**Group of Experts for the revision of the IMO/ILO/UNECE
Guidelines for Packing of Cargo Transport Units**

Fourth session

Comments on Annex 14, Appendix 5

Transmitted by the experts of Japan

“Longitudinal strength of containers

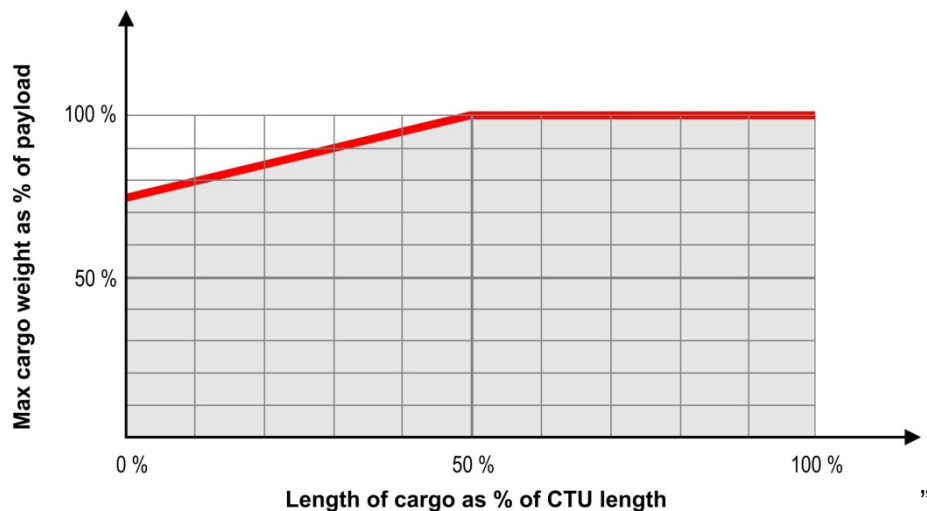
The experts of Japan are of the opinion that the text of paragraph 2.8 may give misleading information or impression that the container has enough strength against 75% of concentrated load to the shipper and/or packer.

The experts of Japan would like to confirm with ISO regarding the strength calculation of CTU and would like to discuss this issue at the fourth session of the Group of Experts.
